Monticello Nuclear Generating Plant
2807 W County Road 75
Monticello, MN 55362

L-MT-15-032
10 CFR 50.90

License Amendment Request to Revise Technical Specification Surveillance Requirement 3.5.1.3.b to Correct the Alternate Nitrogen System Pressure

Evaluation of the Proposed Change

**MONTICELLO NUCLEAR GENERATING PLANT
FIGURE 1 ALTERNATE NITROGEN SYSTEM**

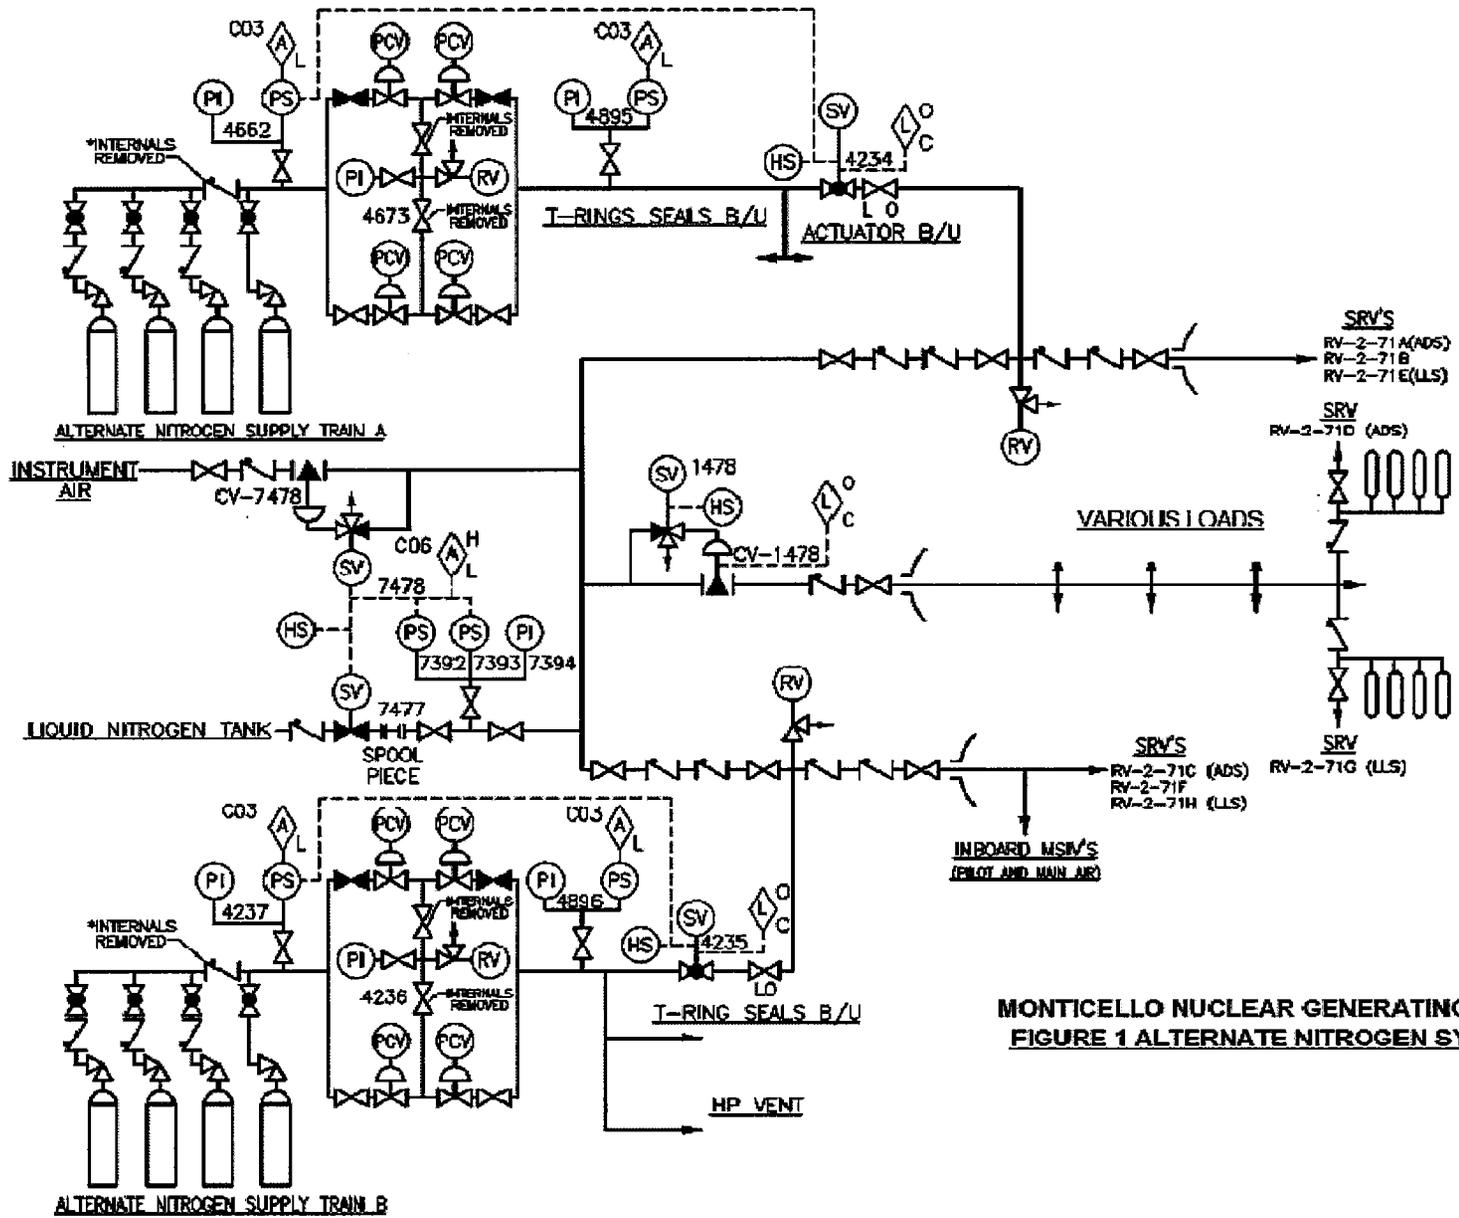
System provides backup pneumatic supply to the T-ring seals of the outboard Primary Containment and Atmospheric Control System purge and vent valves, the actuators of the inboard MSIVs, and SRVs C, F, and H. Train B also provides the sole pneumatic supply to the Primary Containment Hard Pipe Vent System isolation valves and rupture disc. In each Alternate Nitrogen System train, one SRV is assigned to perform the ADS function, a different SRV performs the low-low set (LLS) function, and another SRV is available to perform alternate shutdown and manual depressurization functions. One ADS SRV and one LLS SRV have an associated accumulator bank that provides pneumatic pressure for valve actuation. Figure 1 in Attachment 1 shows the basic Alternate Nitrogen System configuration.
